Application No.: 09/847,759
Filing Date: May 2, 2001

AMENDMENTS TO THE DRAWINGS

REMARKS

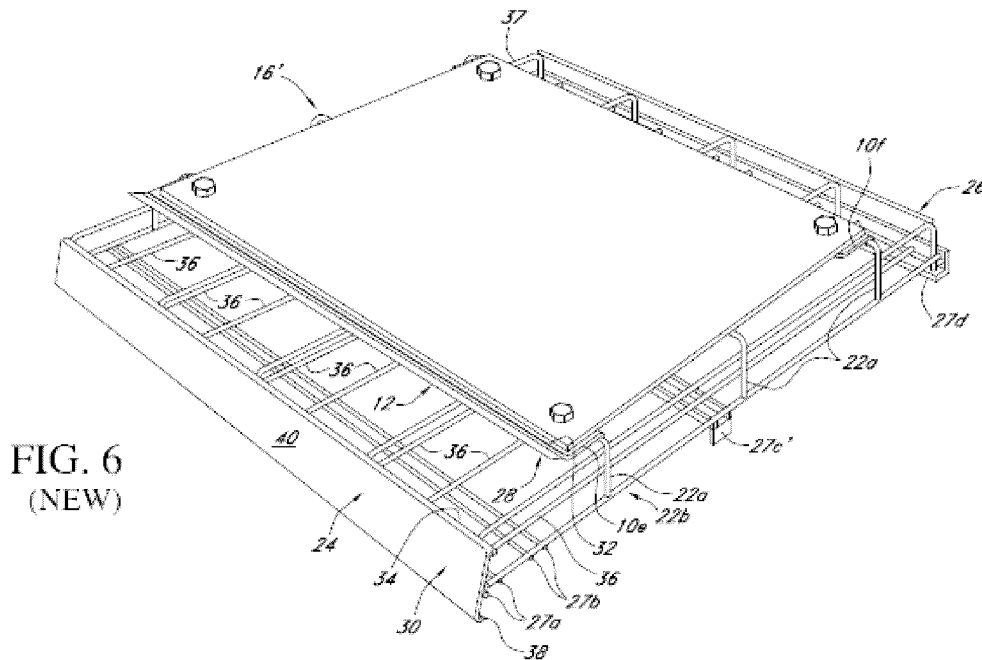
With regard to the rejection that the threaded fasteners 15 extending through the panels 10e and 10f, as shown in Figure 3, constitute new matter on the grounds that the specification does not support the holes themselves being threaded, Applicant traverses. The same rejection was asserted in the Office Action transmitted on September 21, 2009, which Applicant’s Response filed March 22, 2010 traversed and provided arguments showing that Figure 3 did not introduce new matter.

Thus, Applicant submits that there is no basis whatsoever for any new matter rejection. Instead, it appears that the Final Office Action’s position is that figure 3 adds new matter by *inherency*.

Nothing in the MPEP provides for a new matter rejection based on the addition of new matter by inherency. Further, even if there were such a rule, Applicant submits that the schematic drawing of Figure 3 does not necessarily disclose threaded holes in the plates. Rather, the schematic representation of Figure 3 is *generic* to threaded fasteners that cooperate with threads on the plate or additional *threaded nuts*, neither of which are disclosed **or claimed** in the present application.

Applicant thus submits that no new matter has been introduced by Figure 3. Thus, Applicant respectfully requests the current rejection be withdrawn.

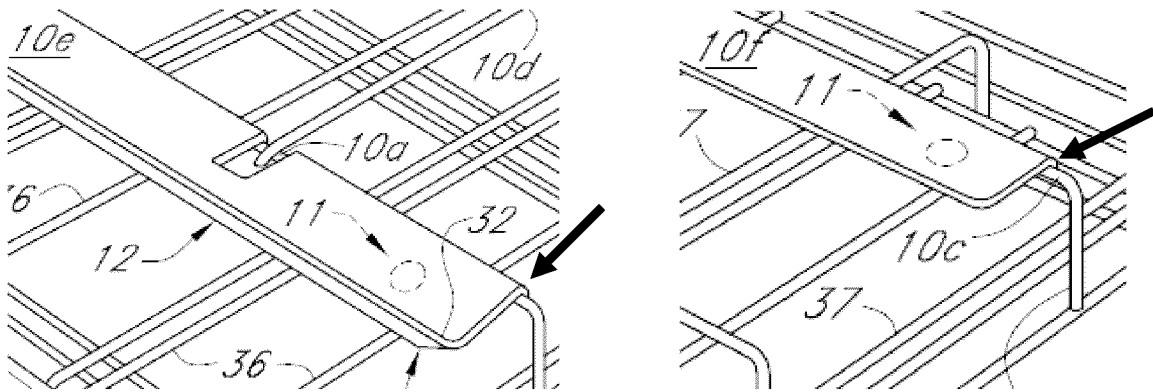
In Response to the rejection of Claim 1 alleging that the recitation "the front rod member . . . defining a first plane" on lines 11-13 of Claim 1, Applicant respectfully traverses. This rejection is based on the stated ground that "it is not clear that the panel member 10e curves downward about the rod members enough to define the applicant's claimed plane." Final Office Action at p. 6. Applicant respectfully disagrees and submits that at least Figure 1 shows panel member 10e curving downward about the rod members. For convenience, excerpts of Figure 1 showing the curve of the panels 10e, 10f are reproduced below:

As shown above, Figure 1 illustrates that the first panel member 10e and second panel member 10f curve downward about rod members 10a and 10c, thereby “defining a first plane” with the front rod member 10a and the at least one other rod member 10b, 10c. Accordingly, Applicant respectfully submits that the claim is not indefinite and requests withdrawal of this rejection.

Fig. 4 of Hickman

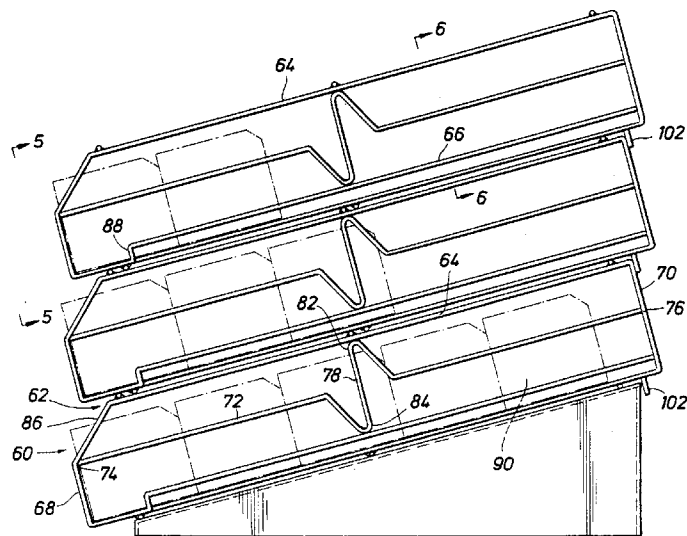
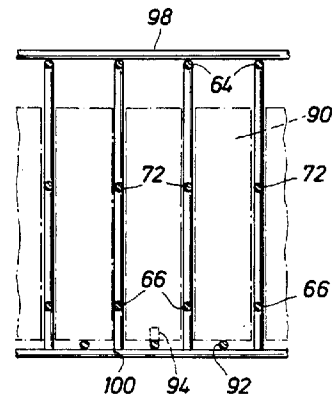
Hickman discloses a stackable storage and dispensing rack for computer tapes. As shown in Figures 4 and 6 of Hickman (reproduced below), the rack includes side frame elements 62 having upper and lower sections 64, 66, intermediate elements 72, front and rear sections 68, 70, and upper and lower stringer members 98, 100. The rack is mounted to an inclined shelf, thus permitting gravity to feed the computer tapes toward the front of the rack.

Hickman fails to teach or suggest at least a “first panel member (10e) extending along at least a majority of the front rod member” and a “second panel member (10f) extending along the at least one other rod member (10b, 10c),” as recited in amended Claim 1.

Additionally, Hickman fails to teach or suggest at least that the panel members be "**configured** to support additional shelving above the first plane, the first and second panel members **also being configured** to support the shelf structure from one of said fixed or adjustable shelves with the shelf structure disposed below said one of said fixed or adjustable shelves," as recited in Claim 1. Indeed, the Final Office Action does not establish any indication in Hickman that would teach or suggest that the rack could be hung, much less any teaching or suggestion concerning a rack having Claim 1's double configuration, *i.e.*, a structure that is configured to mount additional shelving above **and** configured to be supported below a shelf.

Fig. 1 of Olson

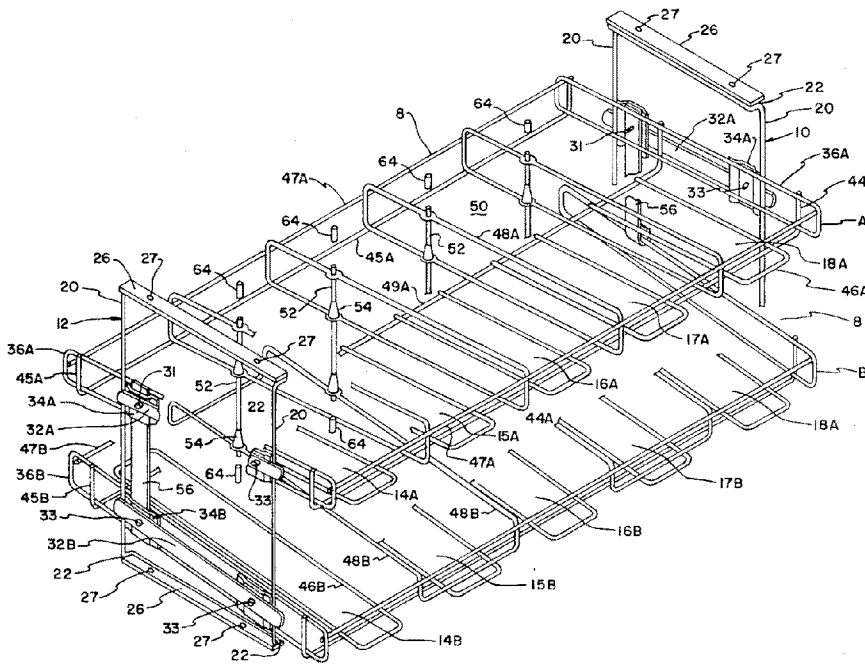
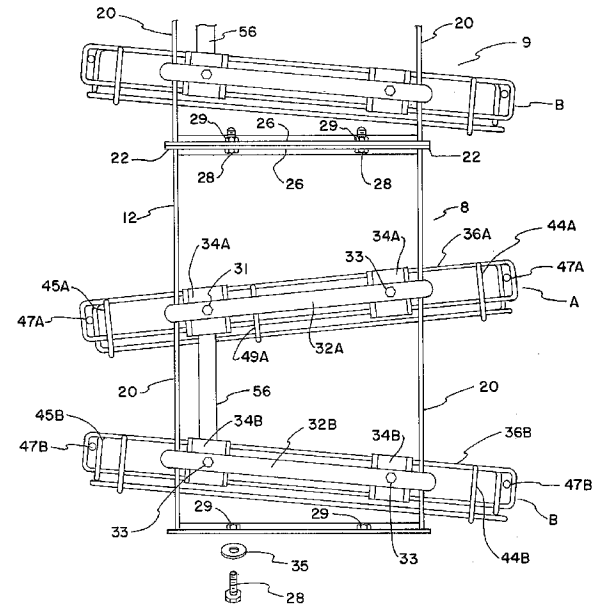
Olson discloses a stackable rack for canned goods. As shown in Figures 1 and 2 of Olson (reproduced below), the rack includes upper and lower track assemblies A, B, which are each divided into a plurality of upper and lower tracks (*e.g.*, 14A, 14B), into which the canned goods are fed. Vertical supports 10, 12 space apart the upper and lower track assemblies and terminate in a support elements 22, which in turn connect to support plates 26. The lower support plate 26 of an upper rack coordinates with the upper support 26 plate of a lower rack to enable the two racks to be stacked and securely fastened together with bolts 28. The lower support plate 26 can also be mounted to a counter with a bolt 28 and washer 35. *See Olson at col. 3, lines 12-35.*

Olson does not remedy Hickman’s deficiency. The Final Office Action contends that Olson’s support plate 26 corresponds to the first and second panel members recited in Claim 1.

See Final Office Action at p. 11. However, as shown in Figure 1 of Olson (reproduced above), Olson's support plates 26 mount to support elements 22 that run parallel to the front-to-back axis of the rack. The support elements 22 are about even with each other relative to the front of rack, *i.e.*, Olson does not have a front support element and rear support element. Accordingly, Olson does not have a "**first panel member** (10e) extending along at least a majority of the **front rod member**" and a "**second panel member** (10f) extending along the at least one **other rod member** (10b, 10c)," where the "other rod member (10b, 10c) [is] **rearwardly spaced** from the front rod member," as recited in Claim 1.

Olson again fails to remedy Hickman's deficiency. Olson teaches a stackable rack and a rack that can be coupled to a countertop via the lower support plate 26 (See Fig. 2 of Olson above). But the Final Office Action does not establish any teaching or suggestion in Olson regarding hanging the rack.
